SUMMARY

EXHIBITS ONE TO SIXTEEN

1. In exhibit one and subsequent exhibits, there is presented a graphic portraying the situation of the operation of several low power FM stations -- those with power less than 3,000 watts and 328 feet on second adjacent channels (± 400 kilohertz), or third adjacent channels (± 600 kilometers) from the local stations' carrier frequency. For many years the commission has precluded stations covering the same area from utilizing frequencies closer than the fourth adjacent channel. See ¶ 73 and 74 of the Commission's rules for specifics.

EXHIBIT (13)

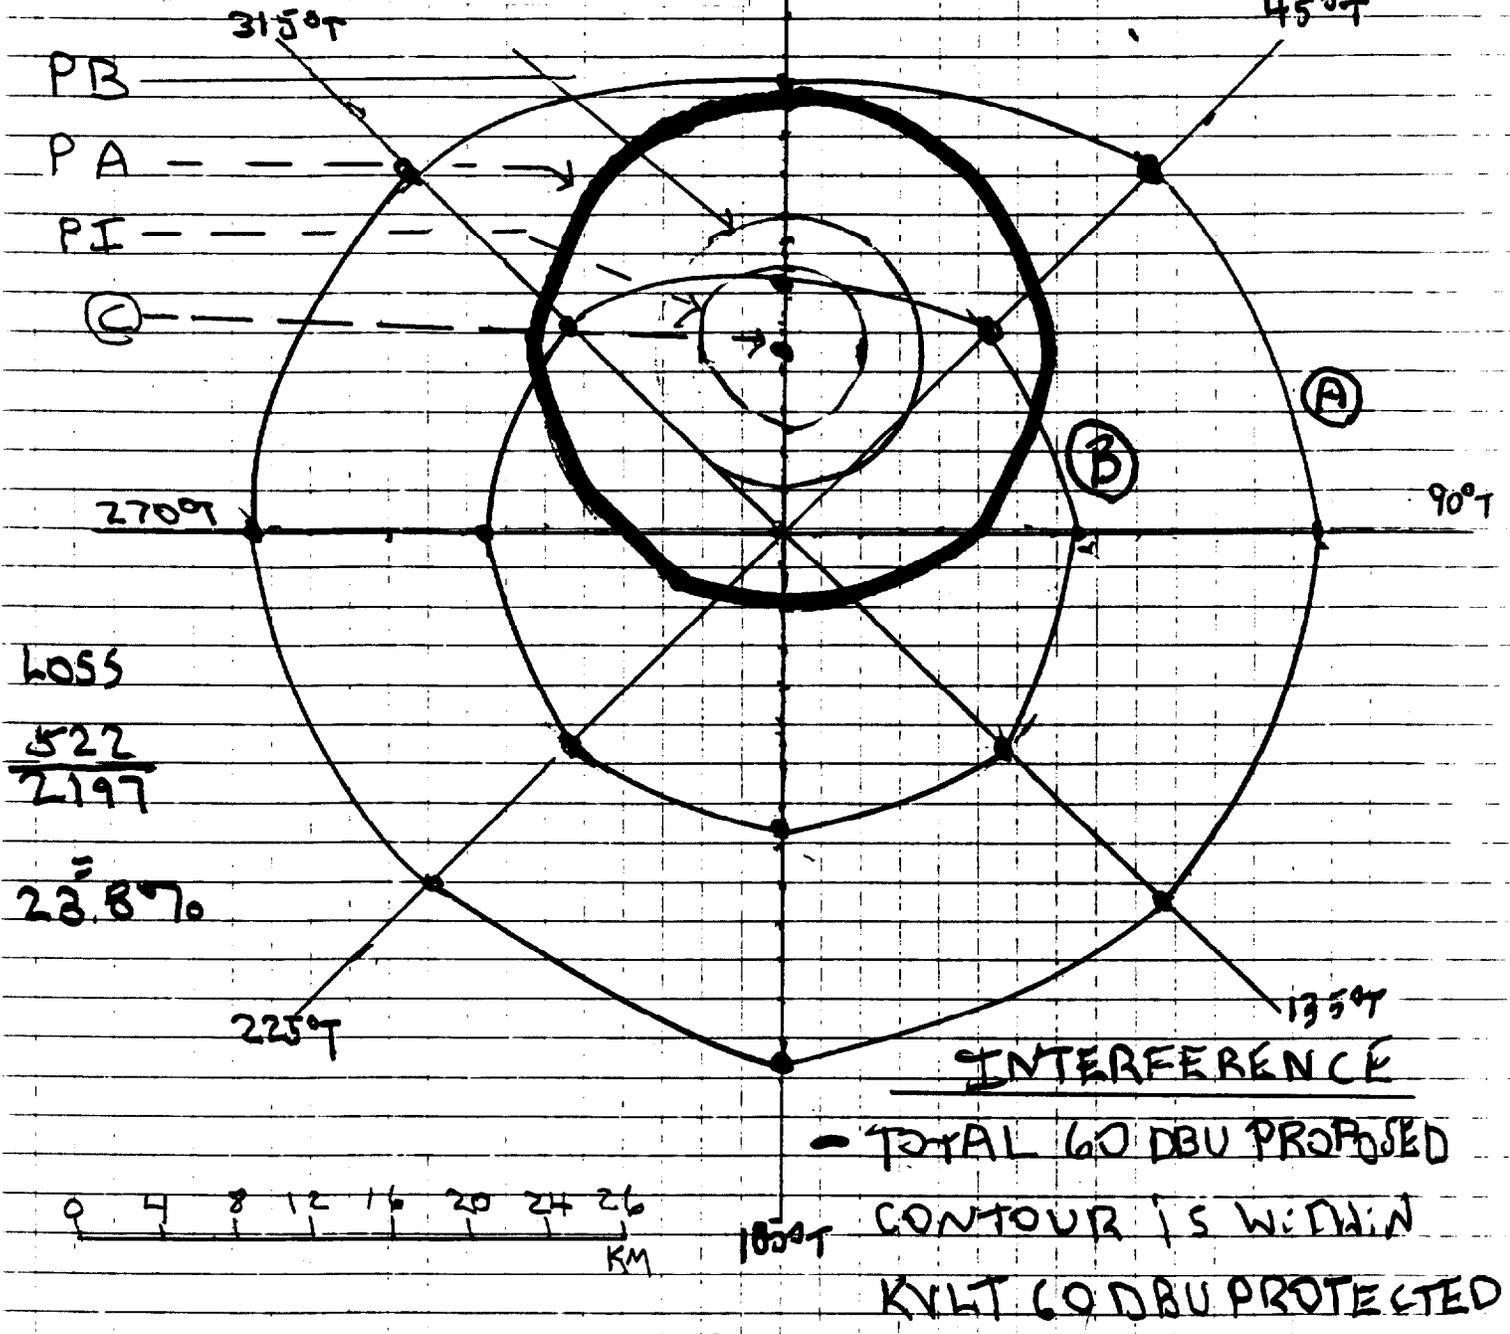
KVL T victim station interference from
 Norwest proposal at ± 400 khz.

14. Exhibits eleven through sixteen are concerned with class A Fm station KVLTV with 6 kilowatts. In eleven it is shown that the city limits of Victoria are not served by KVLTV 70dbu--see area around Walmart. This is due to short spacing to Yoakum, Texas KYKM-FM -- a first adjacent channel. Thus the site of convenience at Walmart is outside KVLTV 70 dbu, but still inside its 60 dbu contour --thus interference is still caused both to the existing station and to the proposed station. In exhibit twelve it is shown that interference is caused to KVLTV from the proposal at Norwest and both stations will suffer interference. KVLTV will suffer a loss of 23.8 % of its 60 dbu protected contour area.

EXHIBIT (14)

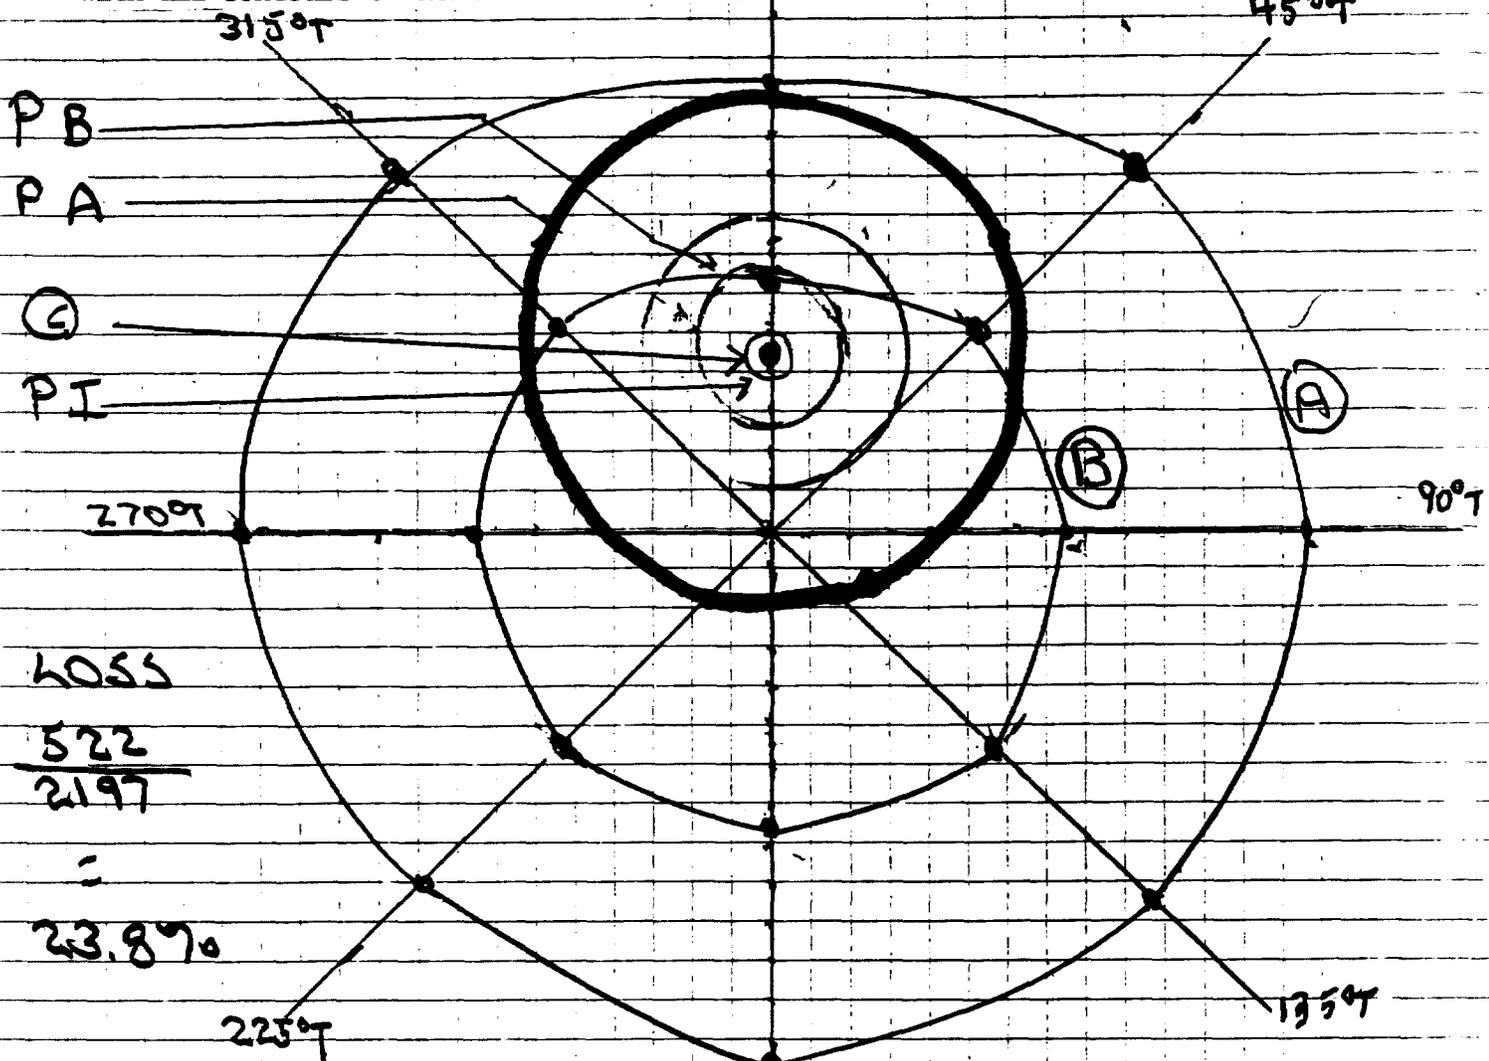
2 KM
 KVL T victim station interference
 from Norwest proposal at ± 600 KHZ
 with all contours of Norwest shown.

INTERFERENCE
 TOTAL 60 DBU PROPOSED
 CONTOUR IS WITHIN
 KVL T 60 DBU PROTECTI

EXHIBIT (15)

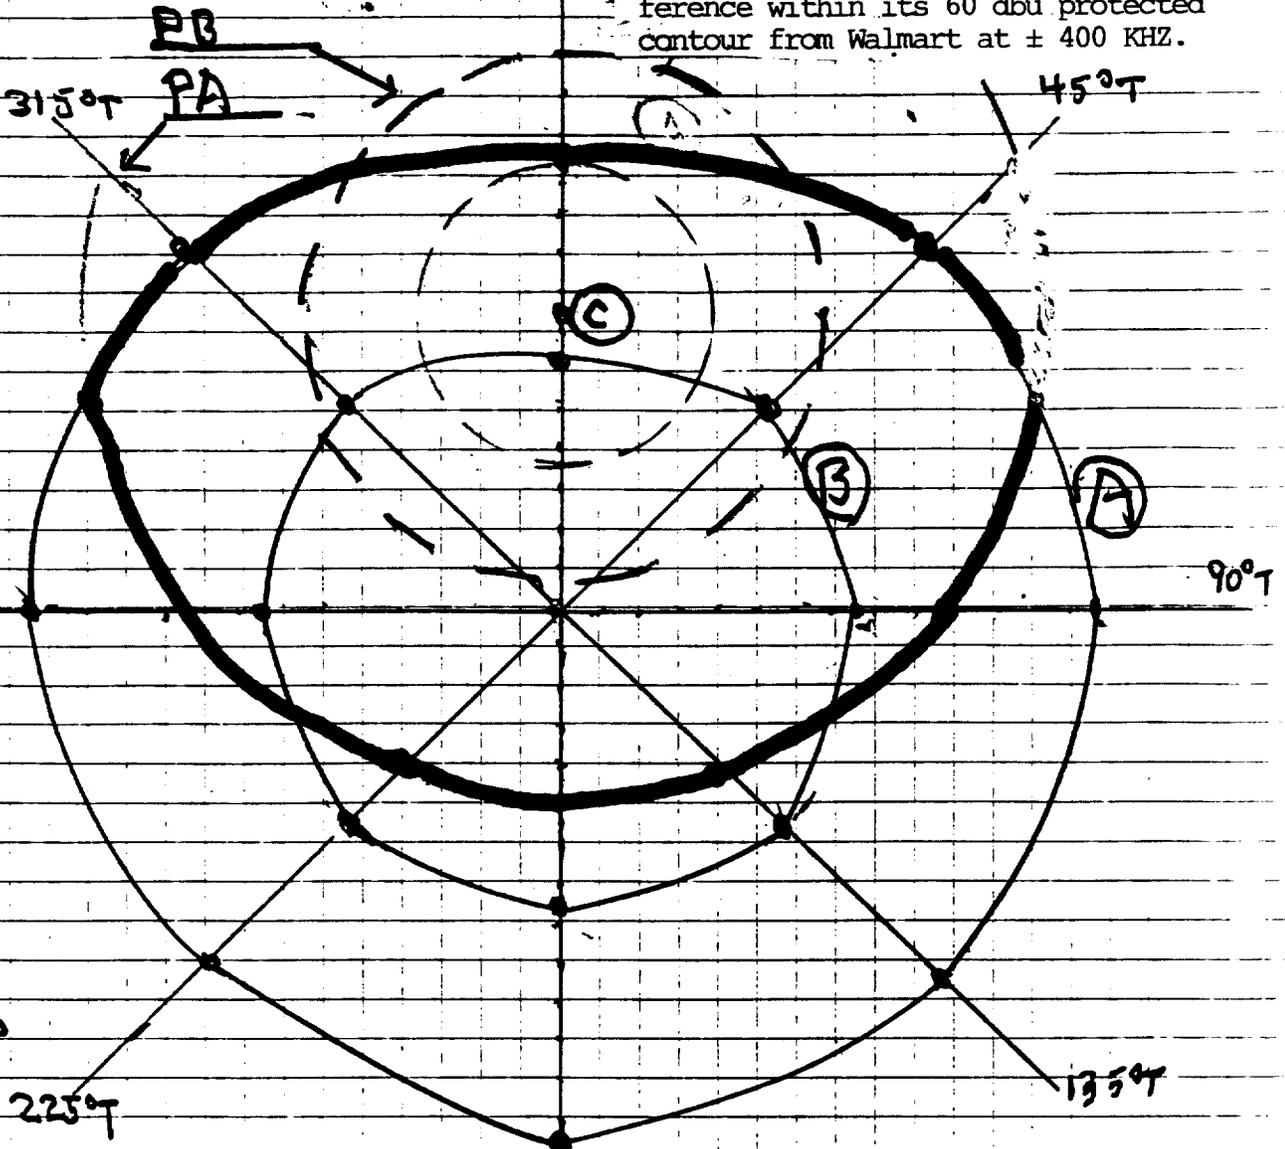
KVL T victim station and areas of interference within its 60 dbu protected contour from Walmart at ± 400 KHZ.

EXHIBIT (16)

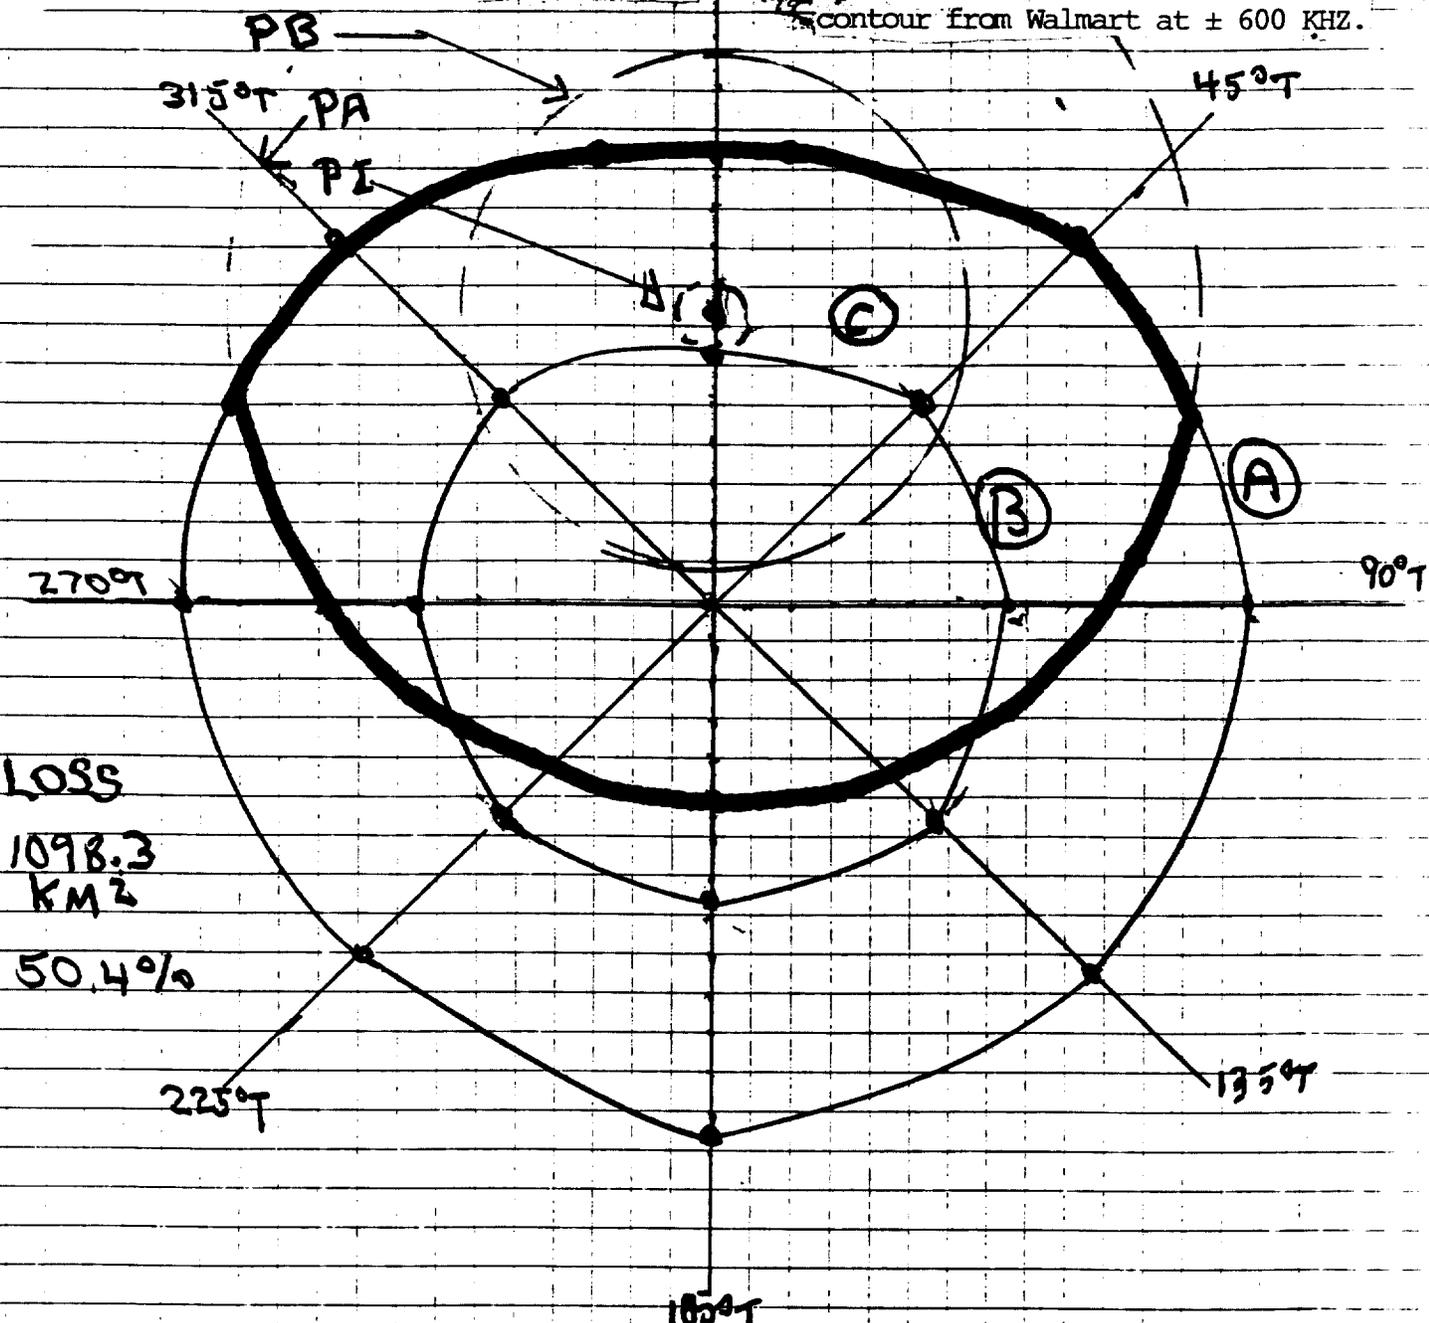
KVL T victim station and areas of interference within its 60 dbu contour from Walmart at ± 600 KHZ.

LOSS
 1098.3
 KM²
 50.4%

15. In sixteen, KVLTV will lose over 50.4% of its 60 dbu contour area as a result of a station located at Walmart. The amount interference will not change if the new station is on the second or the third adjacent channel. There is no overlap of KVLTV 100 , or 80 dbu contours with either the Norwest or the Walmart station.
